Australian Government
National Capital Authority

Report on Consultation

Concept Plan and Development Control Plan 19/02

Blocks 4 and 5 Section 38 Campbell

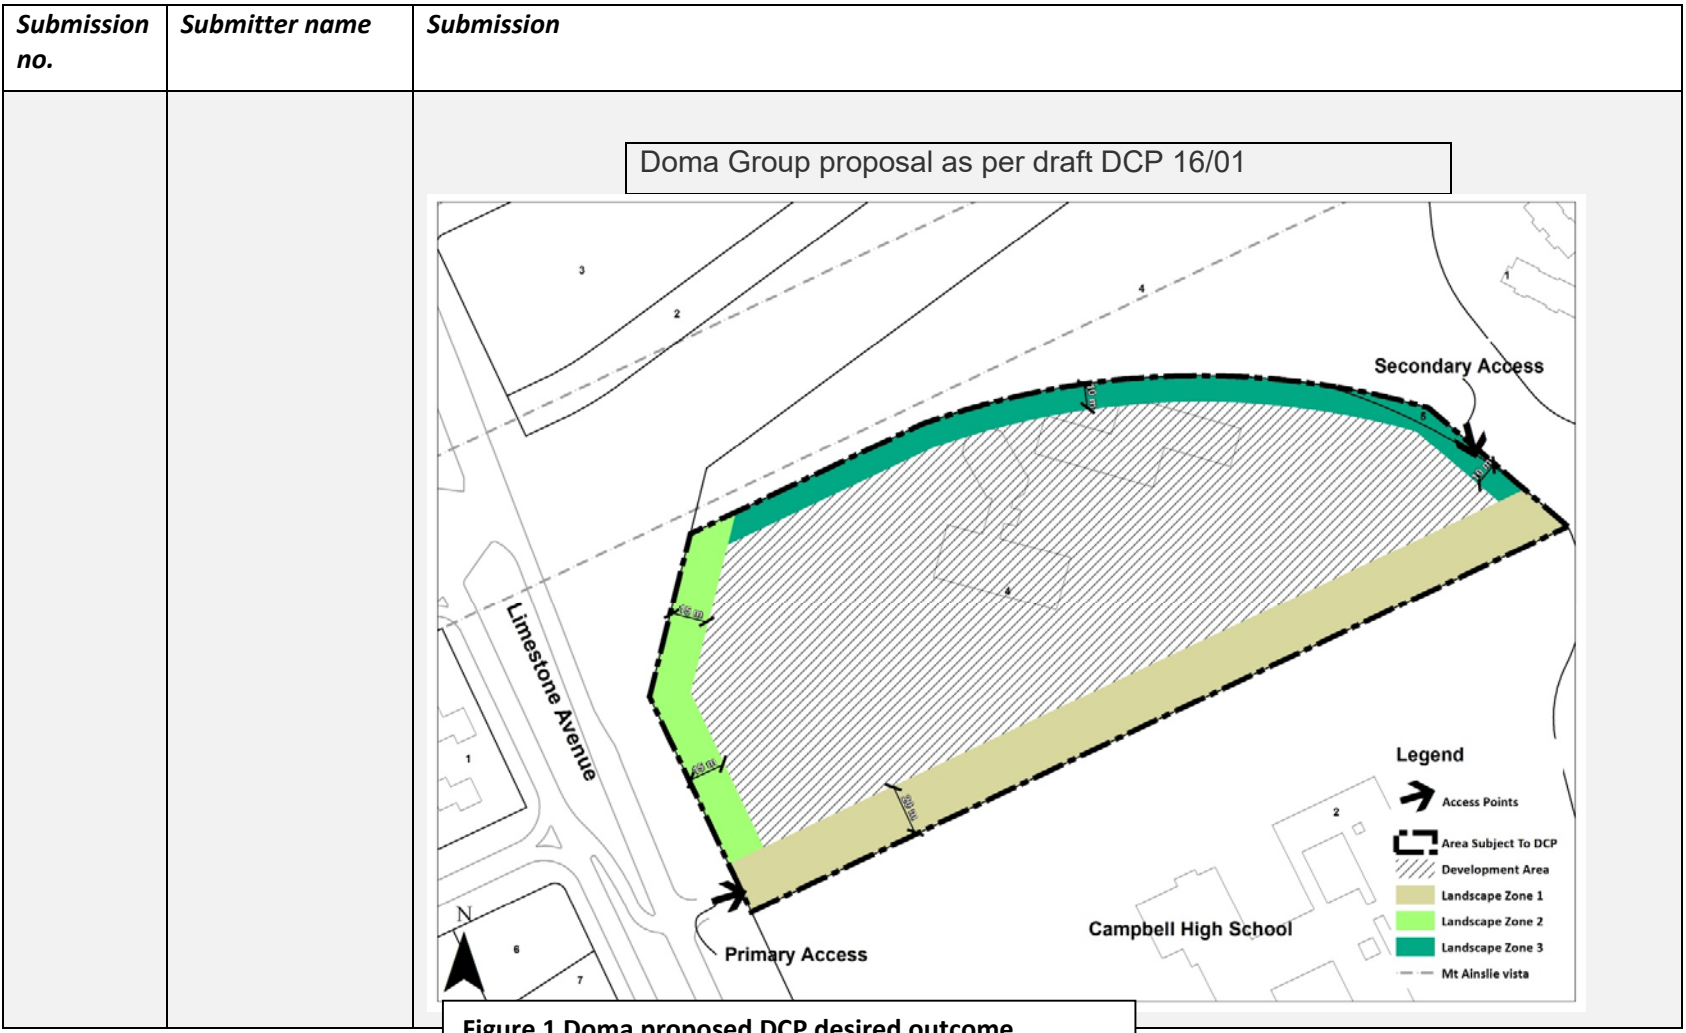
Submission no.	Submitter name	Submission
		 <p data-bbox="728 1157 1220 1204">Figure 2 Response to DCP proposal</p> <p data-bbox="1310 1101 1646 1236">Maintain building line with Campbell High and in keeping with AWM</p> <p data-bbox="705 1268 1758 1300">Greenbelt required to be maintained to preserve the National Estate- AWM to Ainslie Ave.</p>

Submission no.	Submitter name	Submission
		 <p data-bbox="703 1098 1727 1126">Setback and Greenbelt to be preserved as part of the National Estate- Ainslie Ave- AWM</p>
